MEMORANDUM Planning Division – PZ Memo No. 15-051

DATE: MAY 20, 2015
TO: PLANNING AND ZONING COMMISSION
THRU: JEFF KURTZ, PLANNING ADMINISTRATOR [initials]
KEVIN MAYO, PLANNING MANAGER [initials]
FROM: ERIK SWANSON, SENIOR CITY PLANNER [initials]
SUBJECT: PDP15-0003/PPT15-0008 THE PLANT

Request: Preliminary Development Plan (PDP) approval for site layout, building architecture, and a comprehensive sign package, and Preliminary Plat (PPT) approval for an approximate 8-acre commercial shopping center
Location: Southeast corner of Gilbert and Ocotillo roads
Applicant: Garry D. Hays; Law Offices of Garry D. Hays

Overall Elevations THE PLANT

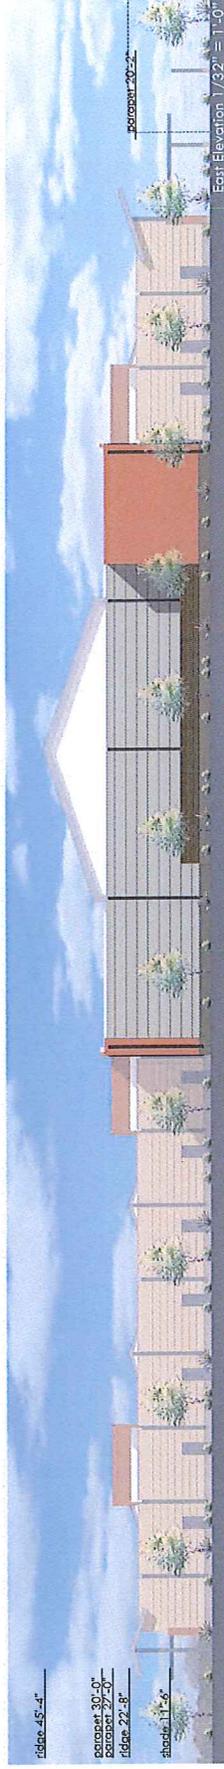
1. Providing light shields on the eastern parking lot lights.
2. Changing the pitched roof color on the rear of the Sprouts from white to a color that would better blend.
3. Incorporating pavement treatments (pavers or stamped concrete) at the entry points to the site.
4. Increase landscaping along the eastern property line by use of trees, berming, green screens, or other measures to provide additional screening of the building from the adjacent canal walkway and Quail Springs neighborhood.

8. change the color of the roof pitch from white to a neutral or earth tone
9. As a gesture of good will- donate 60 trees to our community for additional screening along our view fencing in the park

- Removing the white from the sprouts building and blending the paint color to be more neutral or earth tone. The paint theme throughout should be more like Chandler Heights Marketplace and no white (Garry said he would do it himself. I would pay to see that happen) LOL
- Shades for the lighting in the parking lot

The developer has addressed the first three items of concern; Planning Staff has added condition nos. 12 and 13 addressing the lighting and pavement treatments.
